**ANC 2B DUPONT CIRCLE ADVISORY NEIGHBORHOOD COMMISSION
SPECIAL MEETING, Thursday, January 25, 2006 Jewish Community Center**

STEAD PARK RENOVATIONS

The Commission considered three conceptual designs for renovation of the children's play area.

Design 3:

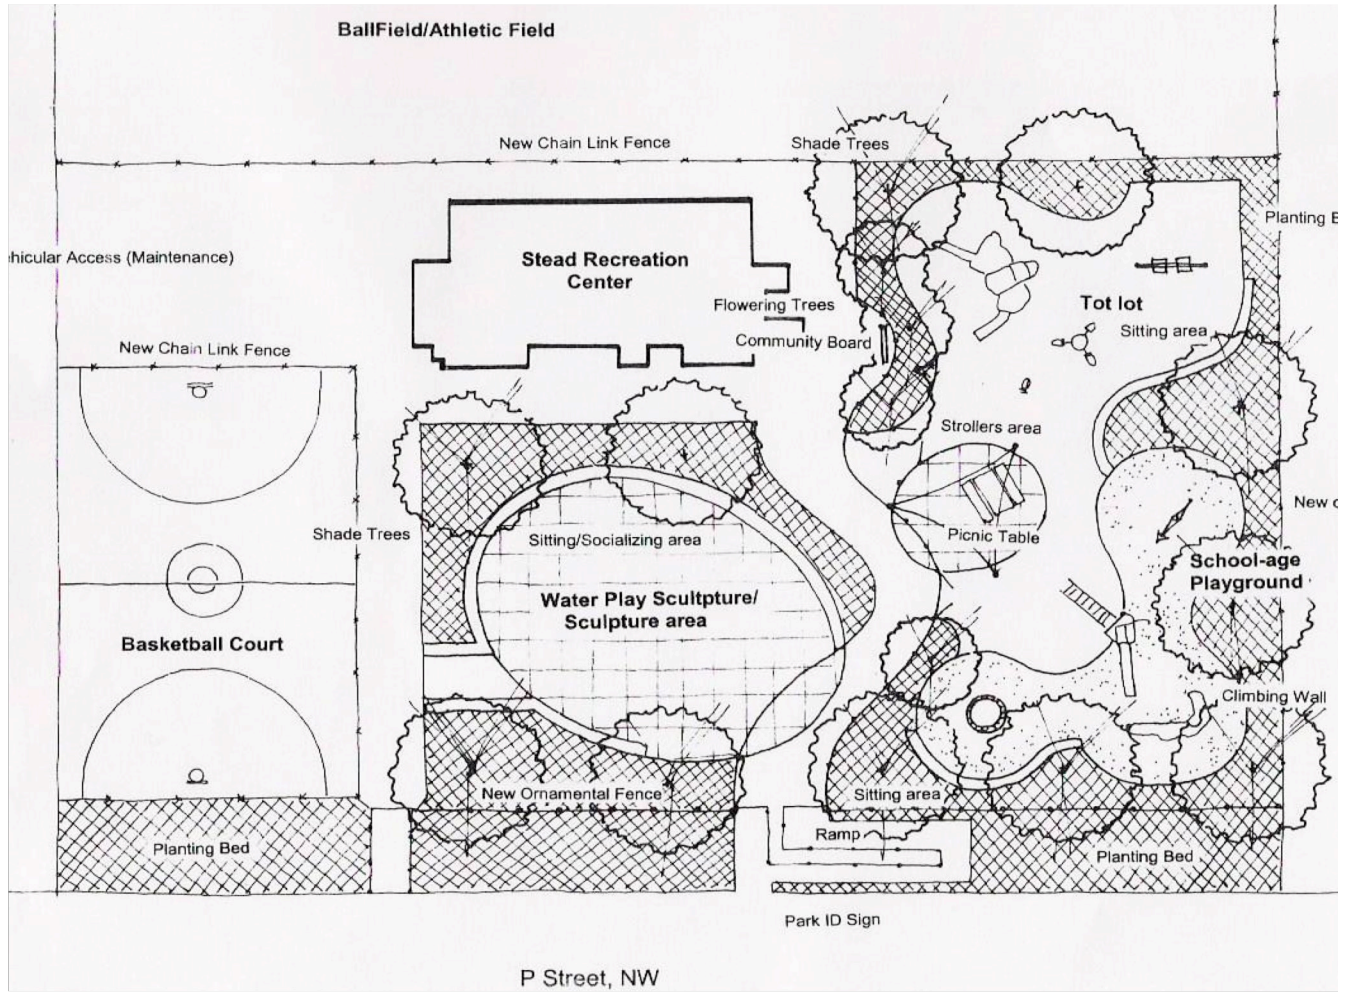
ANC 2B is greatly pleased that DPR potentially will be able to contract for improvements to the playground at Stead Park within the next few months and thanks DPR for its aggressive attention. ANC 2B believes that Concept Design #3 comes closest to the expressed needs and priorities of the Dupont Circle Community. ANC 2B supports DPR proceeding to final design based on the principles listed below and in cooperation with representatives from the Stead Family Trust, the ANC, and Friends of Stead Park.

1. The design should be based solely on the space available between P St and the existing ball field fence. DPR might consider designing flexibility at the North end of the playground next to the ball field fence so that if future park improvements called for extending the playground into the ball field, the new improvements funded this year would not be wasted.
2. All space in front of the rec building, except for the basketball court, should be designed to maximize year-around use by children. Seating space for parents and adults supervising the children should be designed to accommodate any other groups of people coming to the playground for relaxation and the enjoyment of just being there.

3. The water feature is wanted as a priority feature so long as it does not unduly restrict the general use of this space when the water feature is not in use.

4. ANC 2B accepts the elimination of a half-court for shooting baskets so long as the design accommodates at least two baskets outside the full basketball court.

5. Most of the playground surface should be child friendly and all weather.
6. The desire to add gardens on the playground is admirable but it should not detract from the basic purpose of meeting playground equipment needs and the space required around each piece of equipment.

7. The community should confer with an independent playground consultant to inform itself of the design.
8. As a contingency in case there is no redesign of the rec center, the design should incorporate the footprint of a potential future, ground-level fair-weather staff/volunteer work station next to the rec center to supervise the playground and bathrooms and to provide easy access to umbrellas and other equipment.
